# Bureau of Environmental Health

## ONSITE SEWAGE DISPOSAL SYSTEM

PROPERTY ADDRESS: 1751 Underwood Road

SUBDIVISION: Streaker Property

PLAN  
SCALE: 1" = 50'

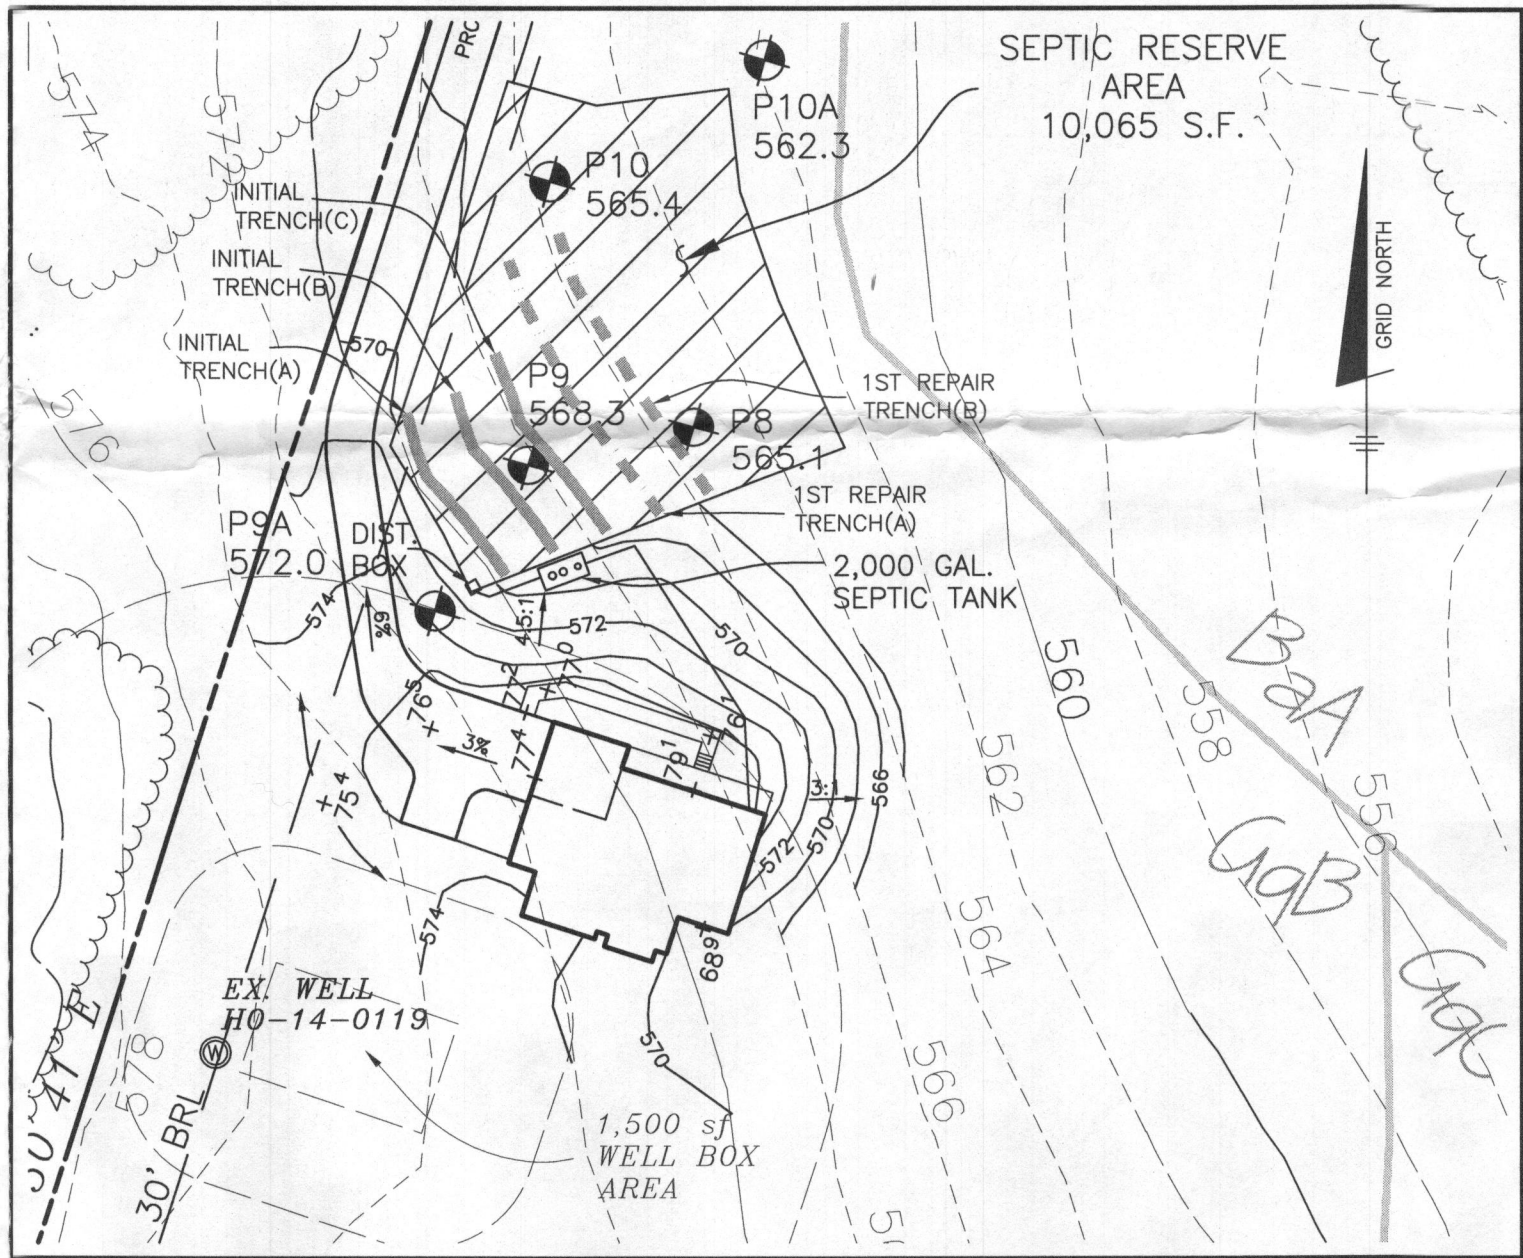
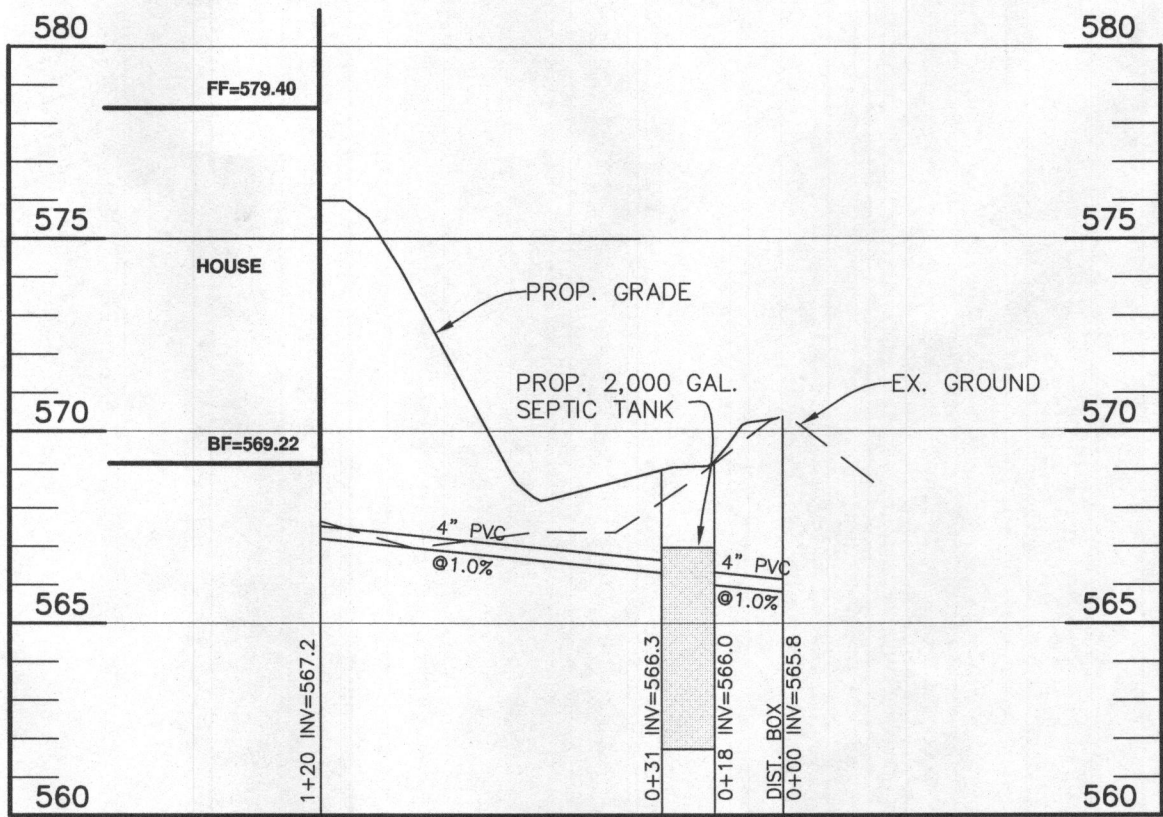
Approved Septic System Plan  
 Howard County Health Department  
 Date: 9/29/16  
 Signature: [Signature]  
 Engineer was warned that the system could possibly be changed in the field to a pump system because of the 1 1/2' fall proposed.
